GENERAL INFORMATION

Location: 9433 and 9435 Riverview Avenue South

Request: A Certificate of Appropriateness for driveway

Case PL2016-127

Figure 2: Existing driveway and proposed driveway configuration

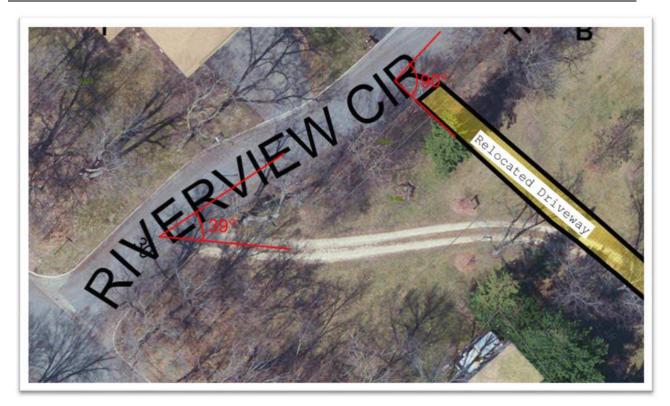
The gravel driveway is difficult to maintain and enters Riverview Circle at a 39 degree angle. The relocated driveway would enter Riverview Circle at a 90 degree angle with more separation from the intersection with Riverview Drive. (See Figure 2). In addition, the applicant would construct a circular driveway at the front of the dwelling. The gravel driveway would be replaced with traditional blacktop and the abandoned portion of the driveway would become a lawn area. The proposed driveway would add approximately 7,300 square feet of impervious surface area.

An asphalt driveway is the only economic alternative to provide access and parking that is consistent with urban homes in the automobile era. The driveway is over 300 feet long and alternatives such as pavers would create a substantial cost. Staff supports the driveway upgrade eliminating the legally non-conforming gravel surface. In 1997 the City Council approved a similar request for a class I historic structure (Rene L.A. Baillif House at 10624 Humboldt Avenue South), although the pavement was bordered by brick pavers to provide an aesthetic balance to the historic home and the asphalt driveway.
